STAFF REPORT

Executive Summary									
Hearing Body:	Millcreek Township Planning Commission								
Meeting Date and Time:	Wednesday, January 16, 2013	04:00 PM	File No:	2	8	0	5	1	
Applicant Name:	Gary Larson	Request:	Conditional Use						
Description:	26-lot PUD subdivision - 6,500 to 13,000 sq. ft. average 6,5000 sq ft. lots								
Location:	1405 East 4500 South								
Zone:	R-2-10 Residential Two-Family	Any Zoning Conditions?	Yes <input checked="" type="checkbox"/>	No <input type="checkbox"/>					
Zoning Condition:	Residential Density limited to 4.5 dwelling units per acres.								
Community Council Rec:	Approval with Conditions								
Staff Recommendation:	Approval with Conditions								
Planner:	Spencer G. Sanders

THE ENCLAVE P.U.D. GARY LARSON
 1405 EAST 4500 SOUTH
 SALT LAKE COUNTY, UTAH

REVISION	12/11/24
SITE PLAN	
CSP.01	
3 OF 19

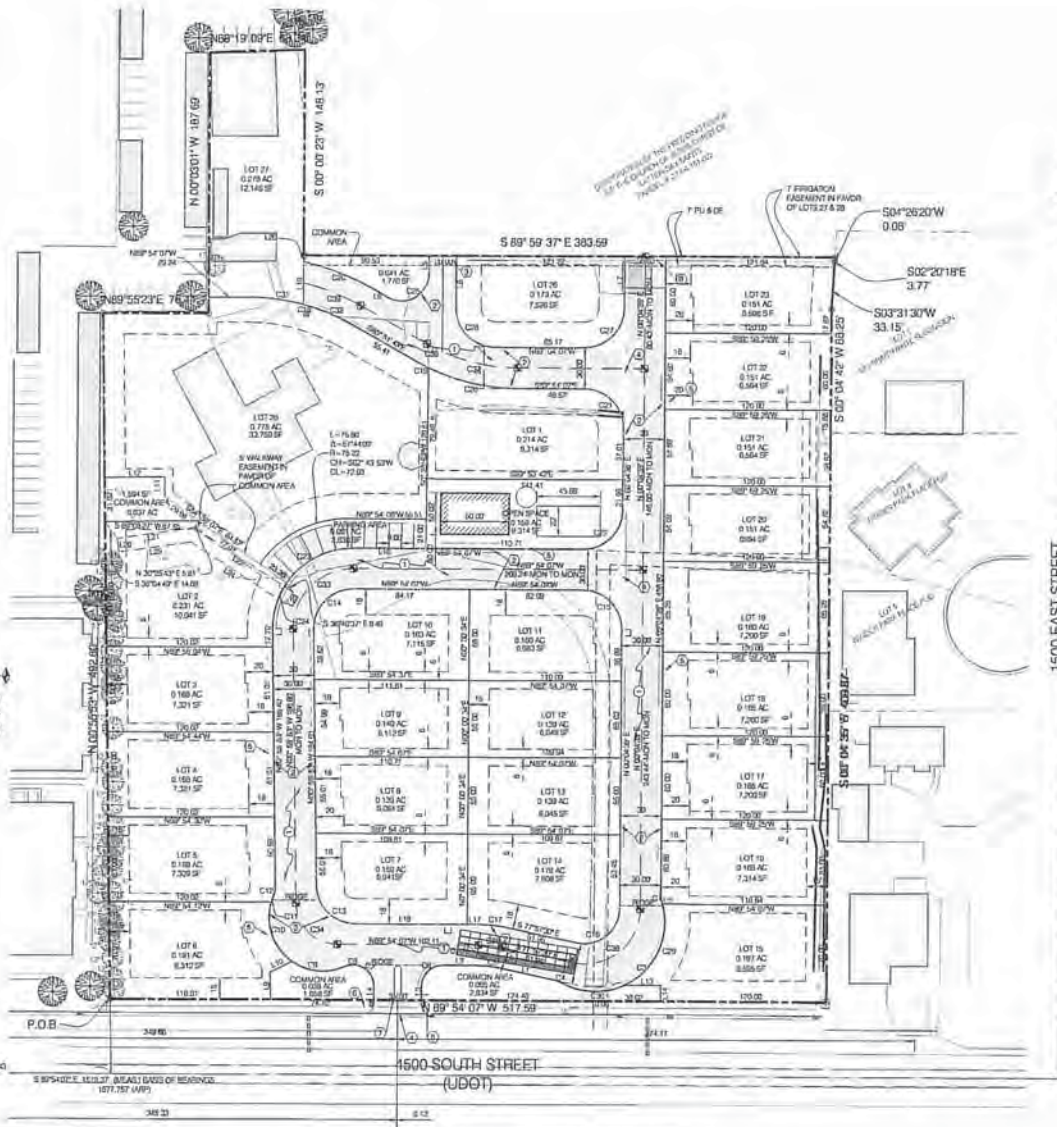
Side Yards from the North Property Line - The northern most lots in the proposed development show a minimum setback of 7 feet from the north property line. This property line is adjacent to a church Open Space area. Based on the configuration of the lots oriented to an internal street perpendicular to the north property line, the north property line becomes a side yard lot line for the two lots at the dead end. However, again RCOZ would require a minimum of 8 feet in this case. Staff supports the 8 feet minimum from the north property line to help ensure that the proposed homes will comply with the RCOZ setback and building envelope around the perimeter of the development. This is consistent with how other PUD developments have been approved under RCOZ. Previous developments have complied with RCOZ requirements around the perimeter of the project, but internal to the project the Commission has given modifications to the standard zoning requirements.

Side Yards adjacent to 4500 South - The proposal shows a 15-foot street side yard setback from 4500 South for the two southern most lots adjacent to 4500 South. The underlying zone requires a 20-foot street side yard setback from public rights-of-way. In review of existing developments both East and West along the north side of 4500 South within several blocks, the structures along 4500 South (single family, multi-family and commercial) maintain a 20 to 30-foot minimum setback from 4500 South. A 15-foot setback would place the residential homes closer than other structures along 4500 South in the area, next to a very large busy right-of-way . Staff recommends that the 20-foot setback be maintained for compatibility with the surrounding area and streetscape along 4500 South.

Sidewalk Internal to the Project - The applicant has not provided any information about pedestrian circulation within the project. Staff is recommending that there be sidewalks within the development since there are a larger number of lots within this project and the residents will need to have pedestrian access to the recreational facilities and out to 4500 South. This may be able to be accommodated within the proposed private rights-of-way or additional right-of-way width may be necessary. Staff is recommending that there be an integral 5-foot sidewalk along all private roadways on both sides. This may require the lots to be reduced in depth by 5 feet. The applicant's proposed typical home plans would still fit on the resulting lots.

Along 4500 South - The proposal does not specify, but it appears that any fencing along 4500 South, except at the entrance of the project, would likely be placed directly behind the sidewalk. This has proven to have maintenance concerns for weeds and for graffiti. Staff is recommending that the fence be of a solid decorative masonry material. In addition it should have some articulation with a varied setback from the sidewalk with a minimum setback of 5 feet. This will provide a planting area to soften the look of the wall, with significant landscaping that screens it. This will also reduce the desirability of such a wall to be tagged with graffiti. Finally, it will enhance the aesthetics of the project from 4500 South and be consistent with other projects along 4500 South in the vicinity.

Existing Structures - The lot in the north western most corner of the development currently houses several outbuildings and equipment for the current owner. As part of the overall lot, these structures are considered accessory uses to the existing home. However, the proposal is to divide this area off into a separate lot. It is staff's understanding that this is to be owned by the current property owner along with the existing home. However, zoning would prohibit accessory uses being located on a lot without a primary use. Subdividing this area into its own lot for potential future development would make the structures non-conforming. Not only would they be on the property without a primary use, but they will not comply with current accessory building setback requirements.

- Side Yard* - 6 feet, 12 feet between homes
 - Side Yard (From North Property Line adjacent to Church Property)* - 8 feet
 - Street Side Yard (Internal to Project from Private Rights-of-way)* - 18 feet

- Street Side Yard (From 4500 South, Public Right-of-way)* - 20 feet
 - Rear Yard* - 15 feet
- 2) **The maximum building height** for homes within the project shall be 35 feet from original grade measured below the ridge-line to the ridge-line of the home's roof.

- 3) **Sidewalks Required** - Five-foot wide sidewalks integral to the curb and gutter shall be provided along both sides of the private rights-of-way within the project. These sidewalks shall connect to: the recreational facilities, including any associated walkways around the facilities; the sidewalk along 4500 South; and the sidewalk along the guest parking stalls. The sidewalks adjacent to the private rights-of-way shall be included in the right-of-way.

- 4) **Fencing along 4500 South** shall be setback a minimum of 5 feet from the sidewalk with additional setback providing horizontal articulation in the fence. The area in front of the fence adjacent to the sidewalk shall be part of the common area of the project and shall be landscaped per approved plans in compliance with County Ordinances.

- 8) **The proposed playground shall be relocated** adjacent to the other proposed recreational facilities in a larger consolidated area.
- 9) **The existing accessory structures on the property shall be removed** from all proposed lots prior to recording, except for the existing home and any accessory structures located on the same resulting lot as the existing home.
